# CERTIFICATE OF SUBSTANTIAL COMPLETION

PROJECT: Otter Creek Clubhouse and  
(Name and address) Community Building  
Otter Creek Golf Course  
Ankeny, Iowa

## Punch List

PARTIAL PLAN C BAR 128  
1/8" = 1'-0"

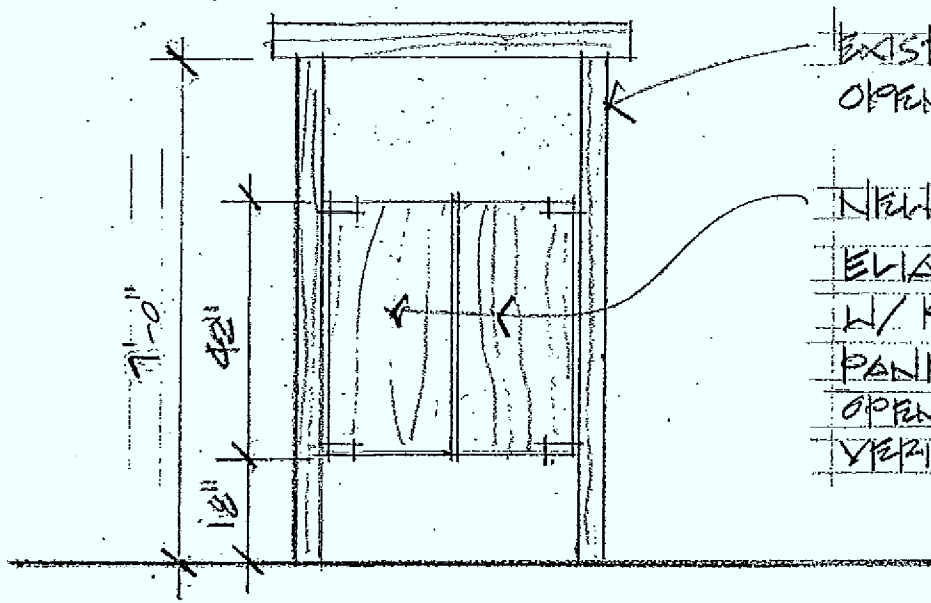
TWO NEW PAIR  
OF DBL. ACTING  
CAFE DOORS

NEW CAFE DOORS BY S.  
ELIASON. MODEL SCIO. CAFE  
W/ P.V.A.M. FINISH. VERIFY  
PANEL WIDTH W/ CASED  
OPENING WIDTH V.I.F.  
VERIFY P.V.A.M. # W/ APPT.
